Re: Watson Cogeneration Steam and Electric Reliability Project

Application for Certification 09-AFC-1

RESPONSES TO JUNE 30, 2011 LARWQCB RESPONSE TO CEC PARTICIPATION REQUEST APPLICATION FOR CERTIFICATION (09-AFC-1)

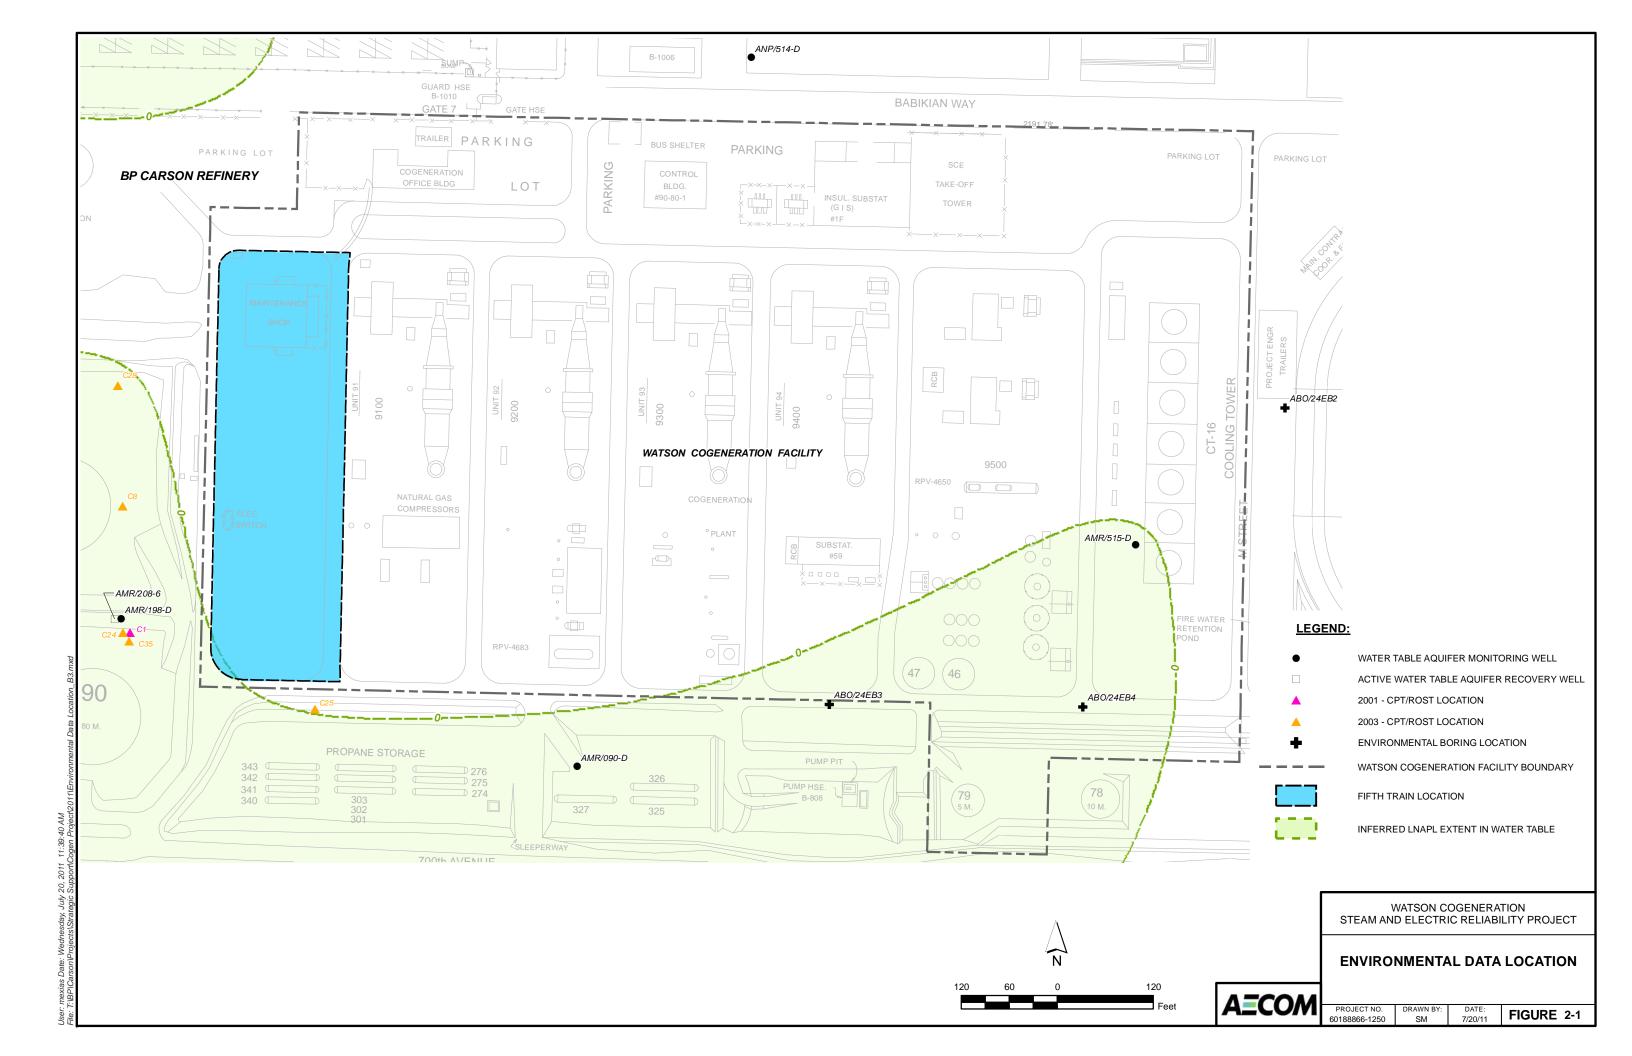
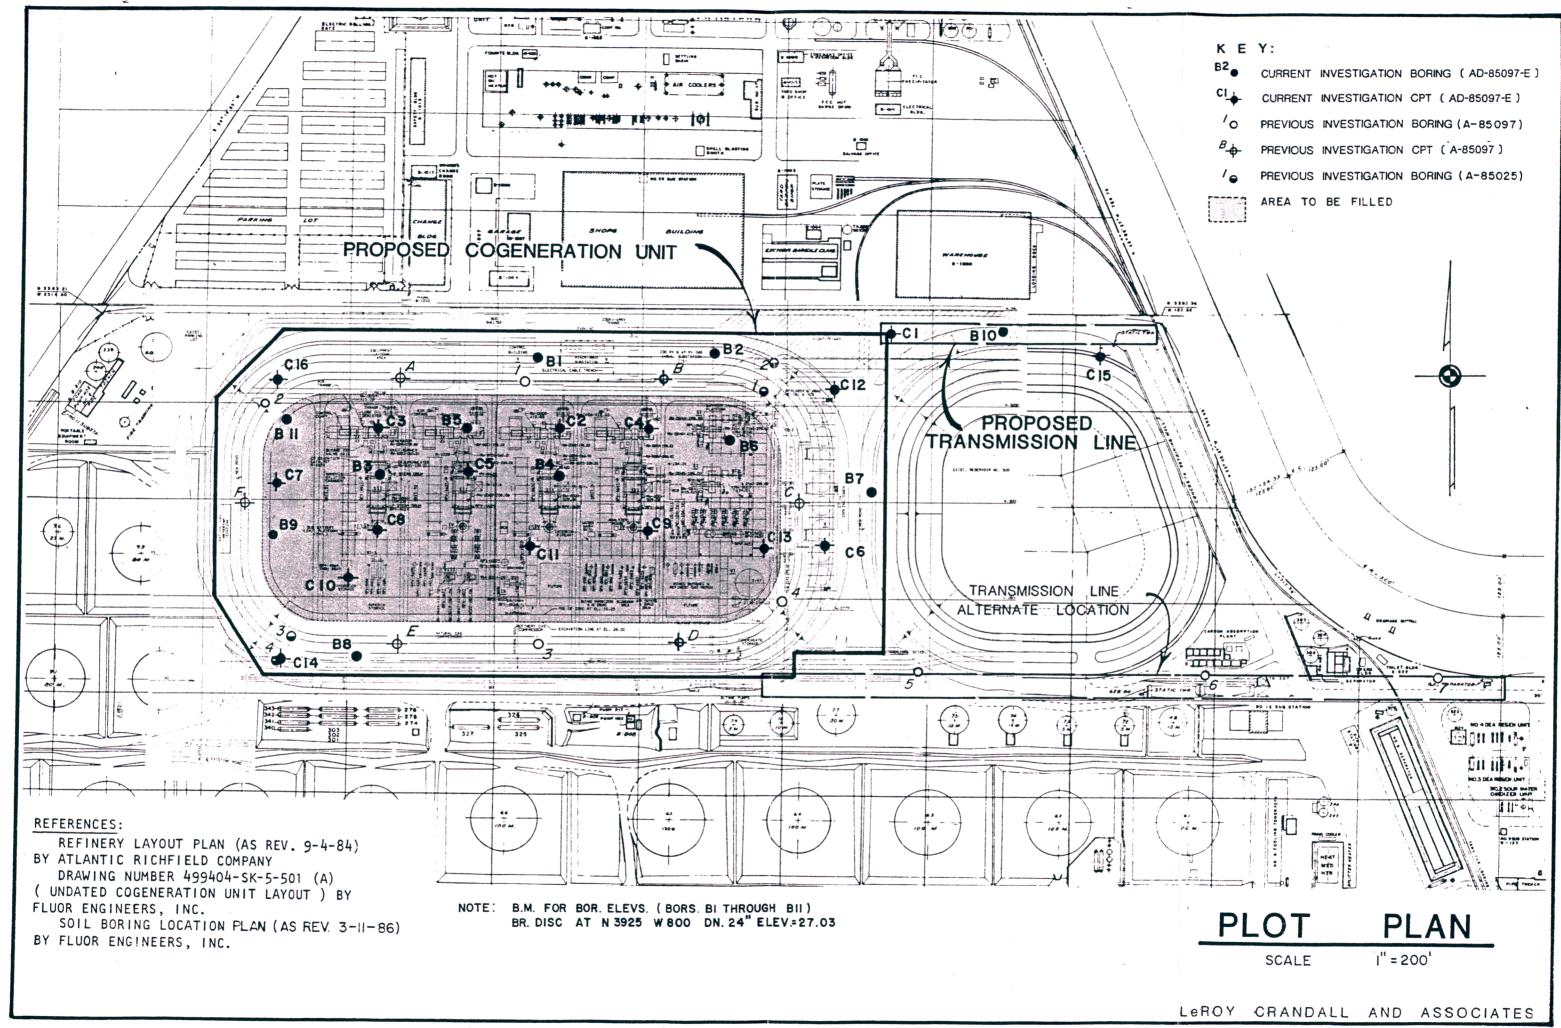
Yes, we believe so in terms of soil excavation or disturbance. In order to better evaluate the specific site contamination and possible health risk issues, staff needs to evaluate all soil and groundwater data at the specific project area.

Figure 2-1, Environmental Data Location, presents the locations of environmental soil borings and existing groundwater wells near the Project Site. Plate 1, Plot Plan, from the 1986 geotechnical report for the existing Watson Cogeneration Facility, presents the locations of the 1985 geotechnical soil borings throughout the Watson Cogeneration Facility, including the Project Site. It has been reprinted in this document for convenient reference. The entire report was filed with the Project's 2009 AFC as Appendix L (Geotechnical Report) and is available on the CEC's website. Table 2-1, Summary of Environmental Data Near Project Site, identifies the

corresponding data reports that were previously filed with either the CEC or the LARWQCB. Appendix A in this response document contains a compilation of monitoring well gauging data (which presents water levels and measured thickness of light non-aqueous phase liquid [LNAPL]) and soil, groundwater and LNAPL analytical data. Appendix B in this response document contains monitoring well logs and logs from the locations of cone penetrometer testing (CPT) and Rapid Optical Screening Test (ROSTTM) Laser Induced Fluorescence (LIF) testing (which detects petroleum hydrocarbons). No soil vapor data was found for the Project Site or the existing Watson Cogeneration Facility.

Additional soil data will be obtained during the Project geotechnical assessment, which will be performed prior to construction.

CONSTRUCTION PLAN FIGURES (FIGURES 4, 5, AND 6 FROM PRELIMINARY DRAFT DRAINAGE, EROSION, AND SEDIMENT CONTROL PLAN)

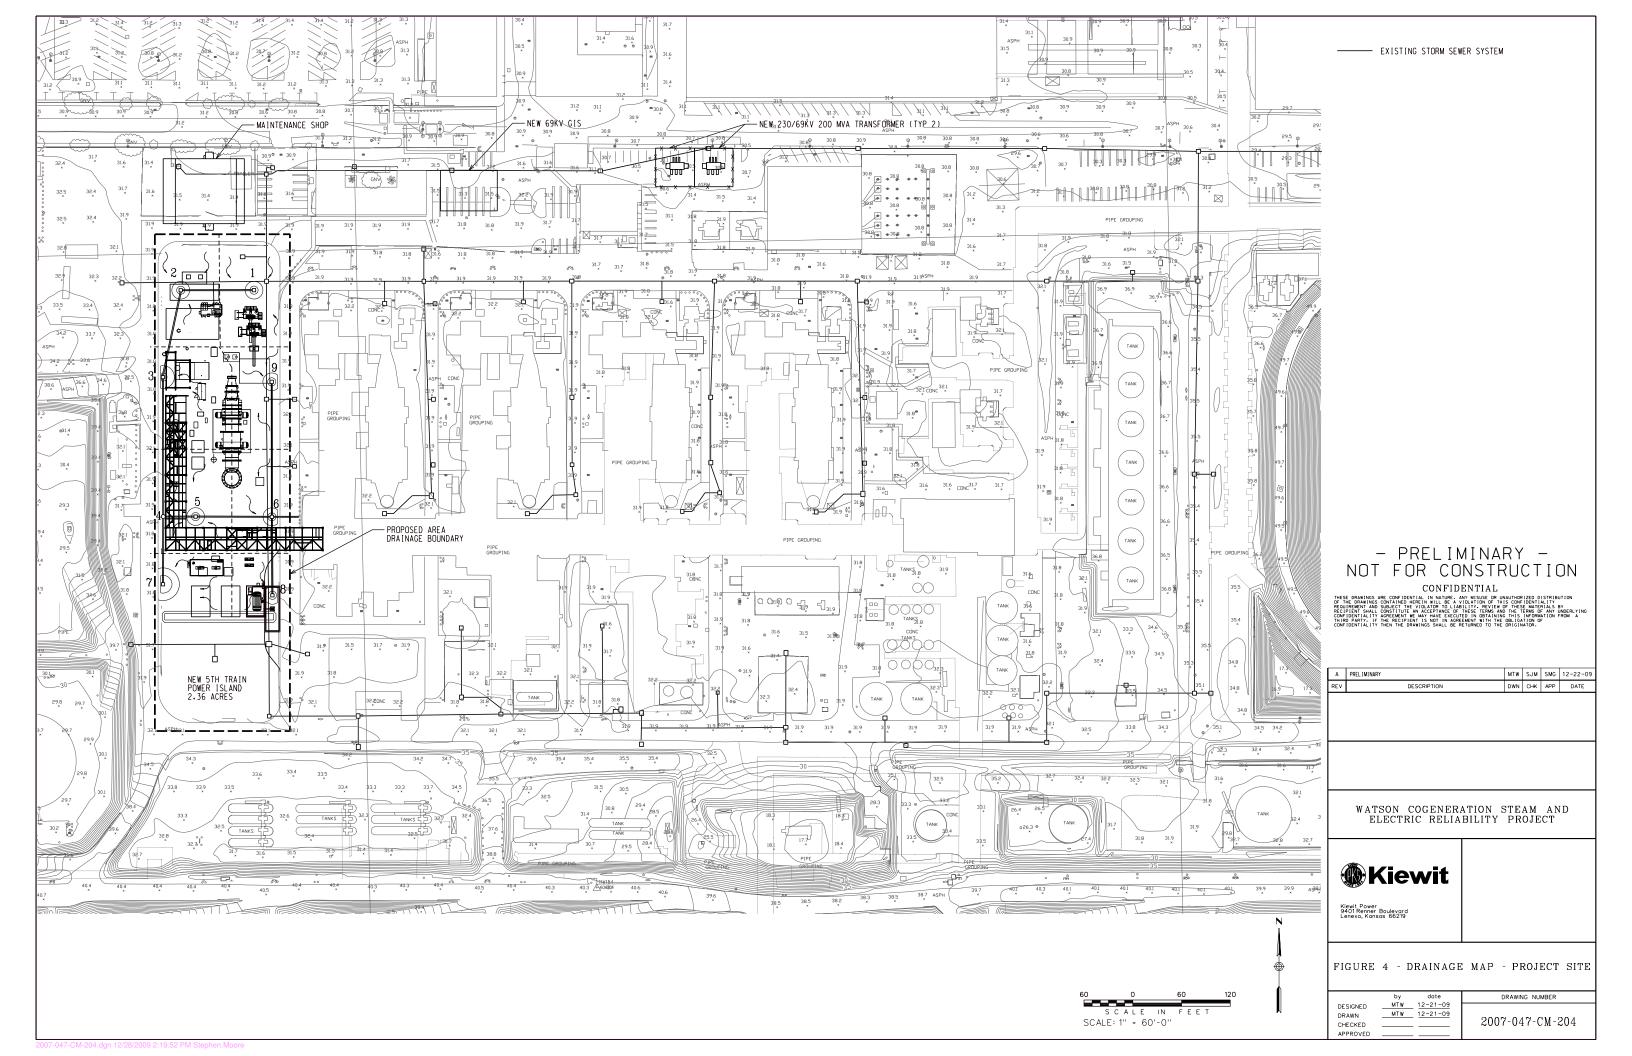
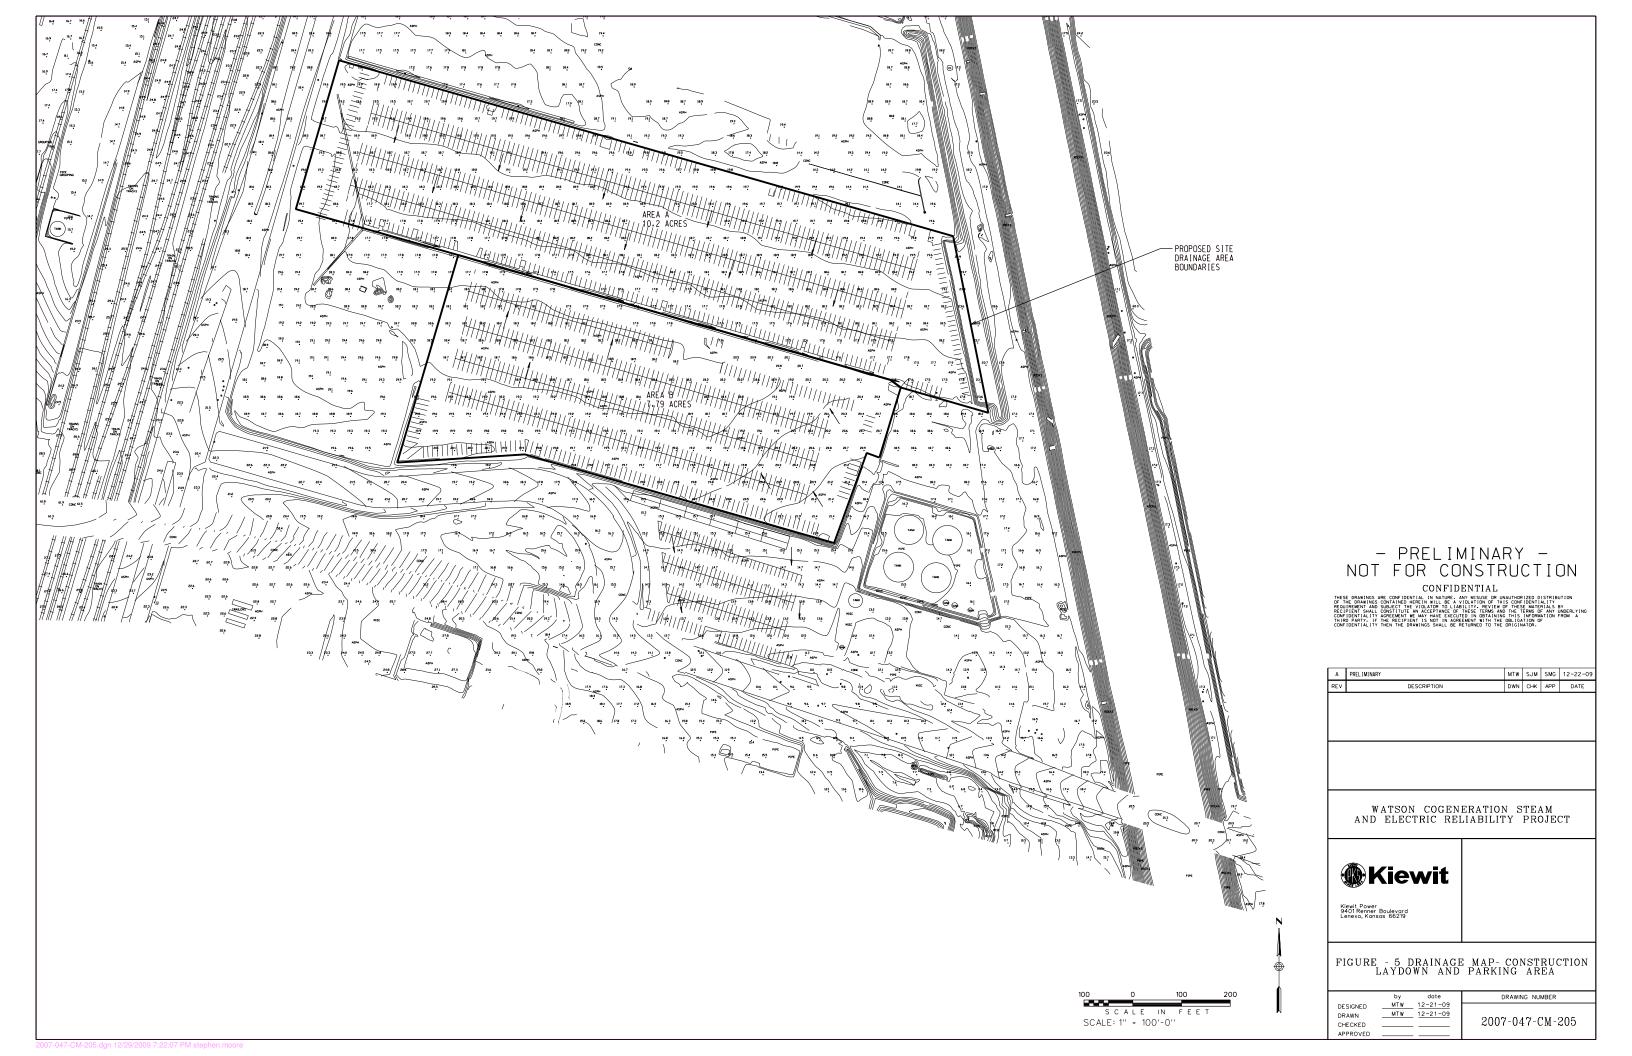
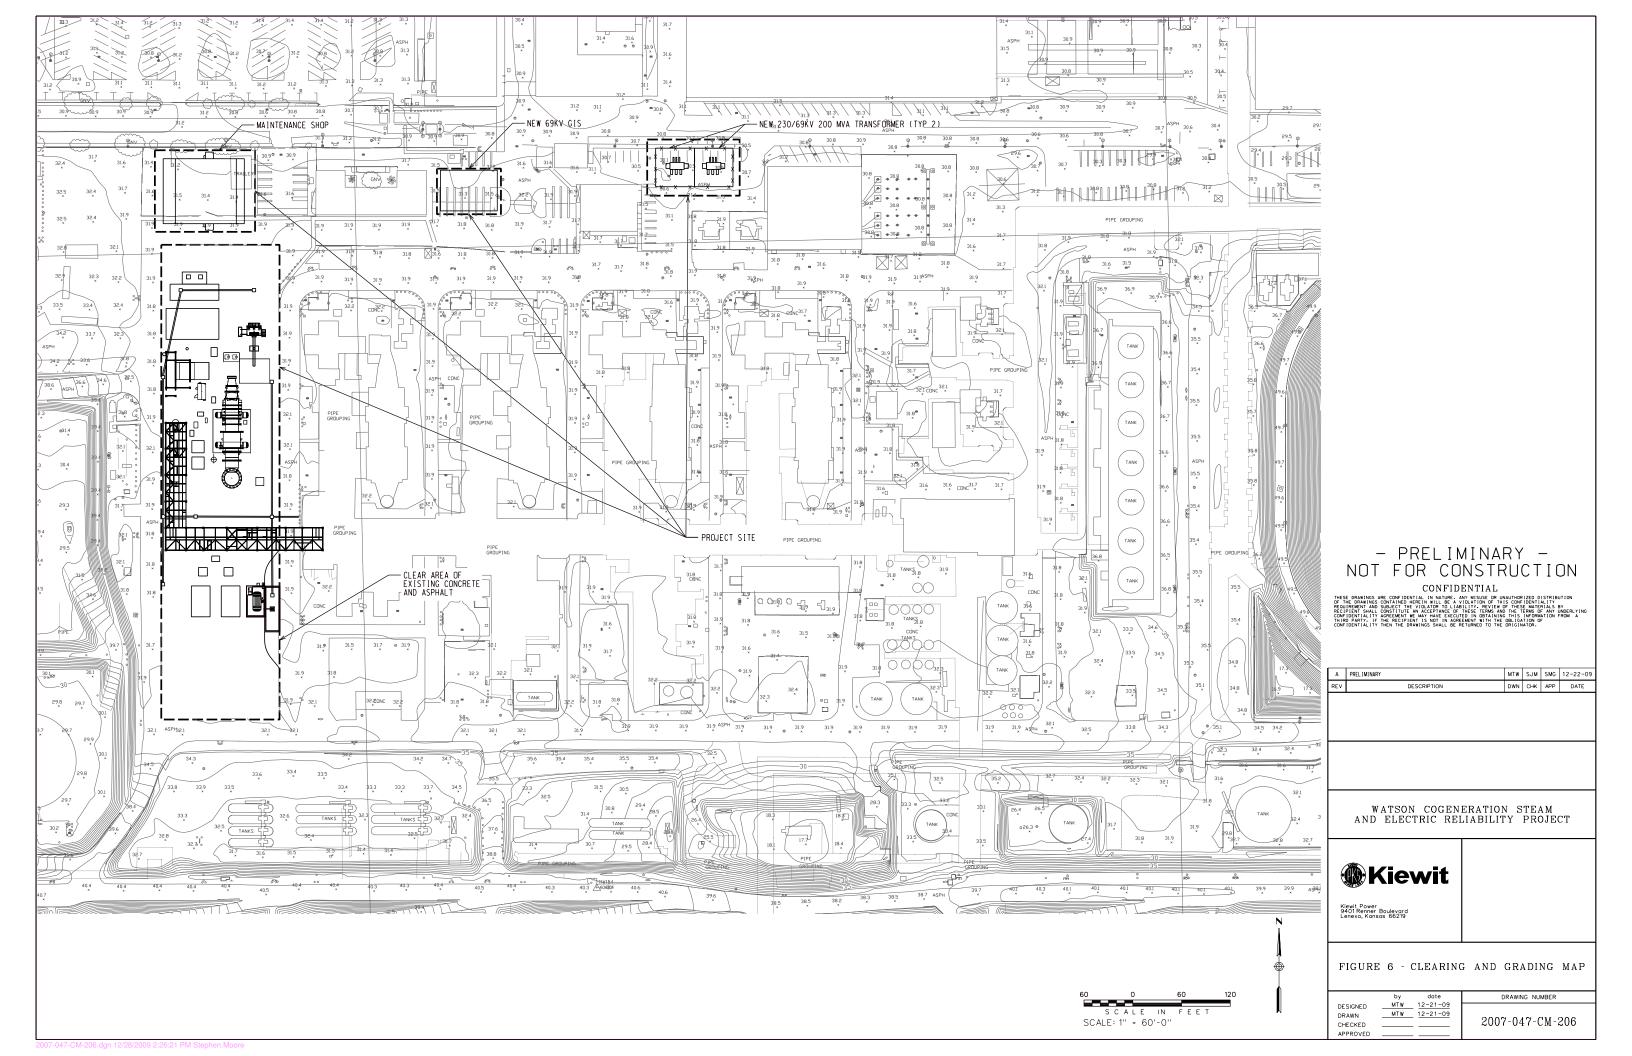
Regional Board staff recommends reviewing the following: (1) the construction plan (e.g., layout, grading plan); (2) the soil management plan; (3) the health and safety plan; (4) the contingency plan for well replacement; and (5) any existing soil vapor, soil and groundwater contamination data at the proposed project area.

- (1) The preliminary construction plan (e.g., layout, grading plan) was previously filed with the CEC as Figure 3-10, Preliminary Drainage Plan, within Section 3 (Project Description) of the March 2009 AFC. In response to CEC Data Request 32, the Applicant prepared a Preliminary Draft Drainage, Erosion, and Sediment Control Plan (DESCP), which contained refinements to the construction plan. The DESCP was filed within the Applicant's January 2010 Responses to CEC Data Request Set 1 (32) and Set 2 (40-48). Figures 4 through 6 (Drainage Map Project Site; Drainage Map Construction Laydown and Parking Area; and Clearing and Grading Map) from the DESCP have been re-printed within Appendix C of this document for convenient reference. Because the Project Site is already developed, grading prior to construction will not be necessary. Only minor grading will be needed after construction to ensure surface water drains properly. No earthwork activity is anticipated for the Construction Laydown and Parking Area.
